UNITED STATES
NUCLEAR REGULATORY COMMISSION

SUBJECT: KEWAUNEE INSPECTION REPORT 50-305/99013(DRP)

Report No: 50-305/99013(DRP)

Facility: Kewaunee Nuclear Power Plant

Simplified Diagram

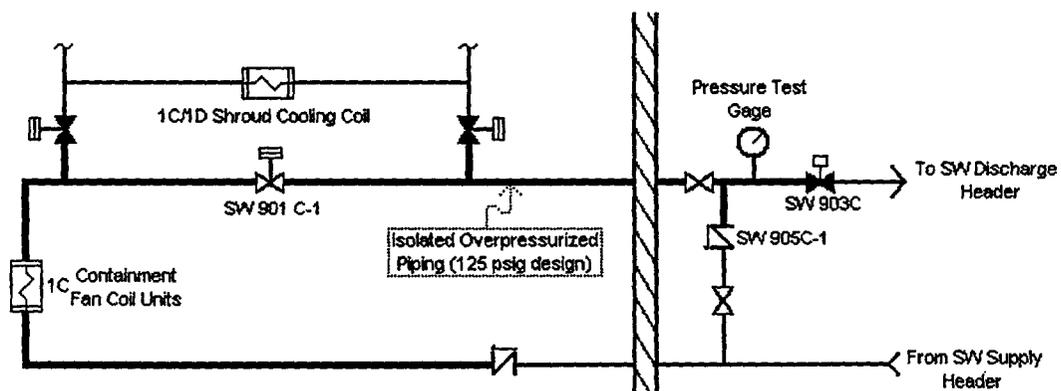
During the performance of motor-operated valve testing on Valve SW-903C, test personnel noted that while Valve SW-903C was closed, the pressure of the isolated portion of the SW piping of Containment FCU 'C' indicated about 150 pounds per square inch gage (psig). The design pressure of that section of piping was 125 psig. The licensee suspected that the cause of the pressure increase was thermal expansion of isolated fluid in the associated SW piping. However, a spring check valve, Valve SW-905C-1, was designed to relieve any pressure increase to prevent exceeding pressure design limits as shown in the simplified diagram below. Valve SW-905C-1 had been originally installed to address GL 96-06 concerns.

The licensee initiated KAP 3723 and WR 217684 to document this condition and to investigate the cause of the failure of Valve SW-905C-1 to relieve pressure as designed. Additionally, the licensee performed an engineering evaluation which concluded that the increased pipe stresses due to the overpressurization were negligible compared to the allowable stresses for the piping material in use. The inspectors reviewed the licensee's operability determination documented in KAP 3723. The inspectors noted that KAP 3723 contained administrative controls for the operation of Valve SW-903C to ensure that GL 96-06 concerns were satisfied. The inspectors did not identify any deficiencies with KAP 3723.

Additional troubleshooting determined that Valve SW-905C-1 was fouled and stuck closed. The valve was then cleaned and reassembled. The licensee subsequently retested Valve SW-905C-1 with satisfactory results. The inspectors noted that the licensee questioned the operability of Valves SW-905A-1, SW-905B-1 and SW-905D-1, which are the spring check valves associated with the other containment FCUs. The licensee subsequently performed testing of the other spring check valves and determined that they were functioning as designed. Additionally, the licensee planned to disassemble and inspect the remaining check valves to ensure proper operation.

During motor-operated valve testing, test personnel observed that the pressure of isolated service water piping exceeded the design pressure. The overpressure condition was the result of a spring check valve that was stuck closed. The inspectors reviewed the licensee's engineering evaluation and administrative controls and did not identify any deficiencies. Additionally, the inspectors noted that the licensee adequately evaluated other similar spring check valves for potential common mode failure mechanisms.
